Explanation of Drawing 8296/1A

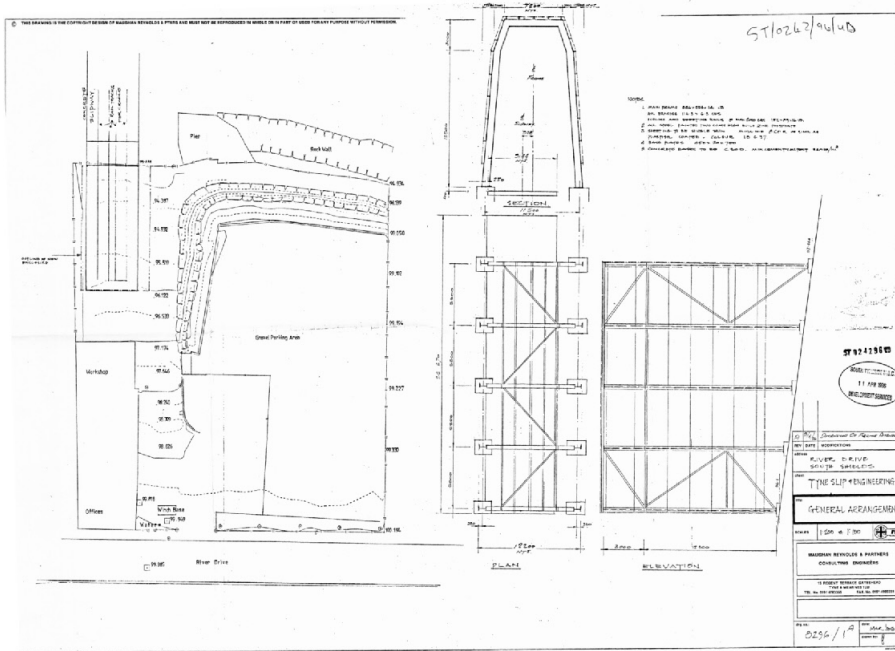
3. The fall along the length of the shed is 2.6m
4. A full sized A1 drawing was kindly provided by Mr Mansbridge, the Head of Development Services and I have used this to get a solution to calculate dimensions.

6. Both ends of the shed are shown as 15.5m and this cannot be true.
7. The Planning and the Development Services Department say that the road (south) end is 15.5m high. This is the word of the applicant.

8. I say that the height of the road end is 12.5m high and back it with the explanation below.

2) The height of the river end (2)

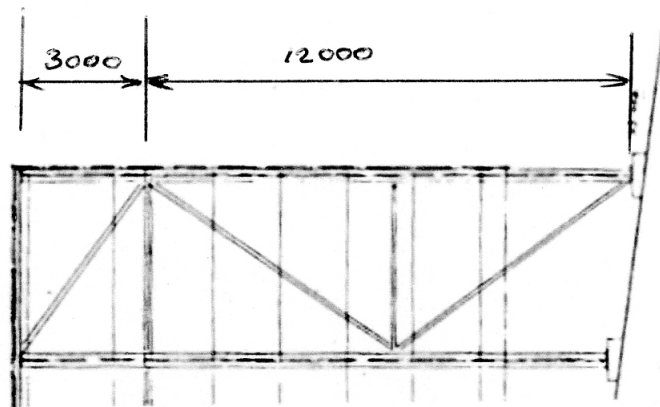
The river end of the side elevation has no dimensions in the drawing. There is no requirement for them as they are given on the gable end detail. They can be worked out however: the depth to the hip is 3m (see below) and by proportion from hip to ground 12m giving a total height of 15m.

3) Height of the road end (south) elevation: below.

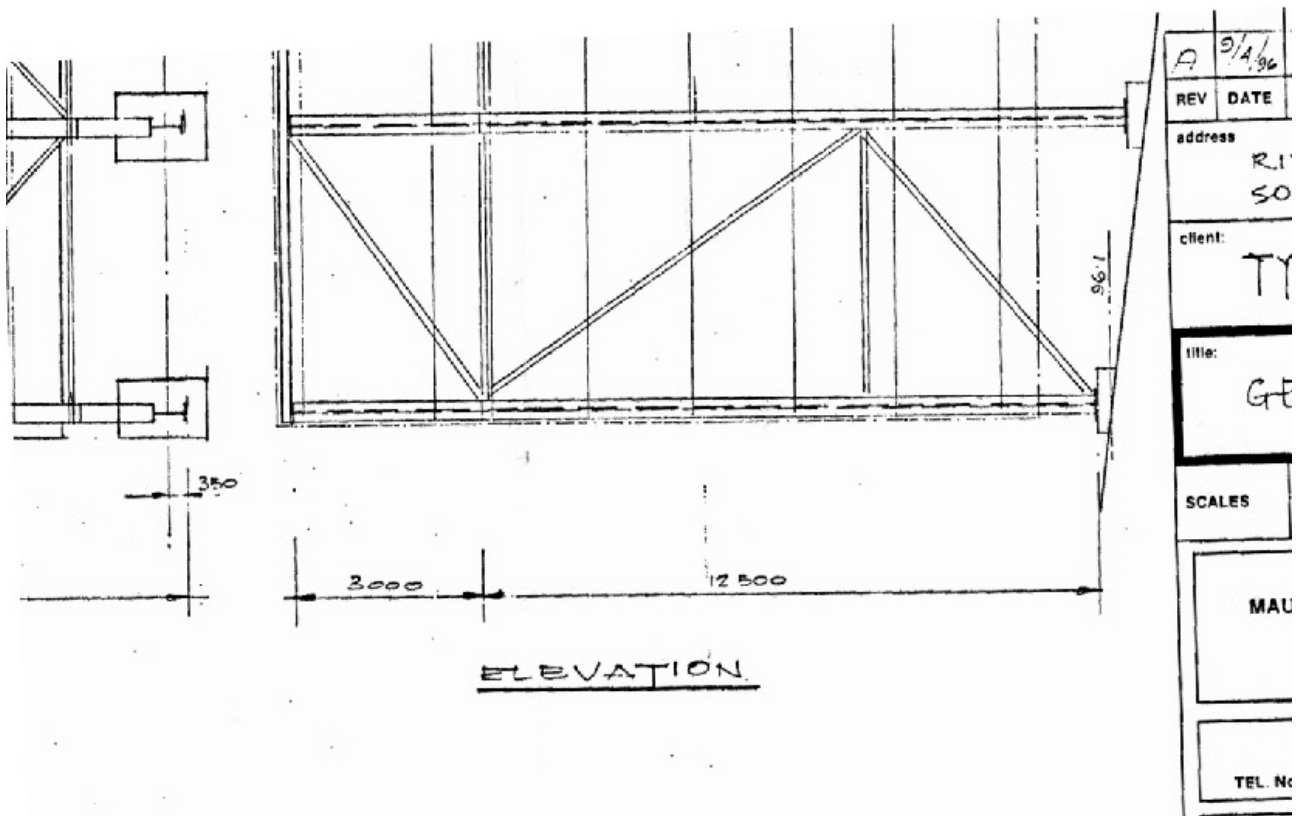
Using the depth to the hip of 3m the height from hip to ground works out at 9.7m giving a total height of 12.7m. The 12.5 dimension should be pointing to the top of the shed. If this drawing equivalent of a typing error is corrected then the drawing makes sense. The road end of the shed has a planned height of 12.5m

The Planning Office have put forward an explanation to try and justify a road end height of 15.5m and account for the fall of 3m by making the planned height of the river end 18.5m. This cannot be supported if one looks carefully at the drawing.
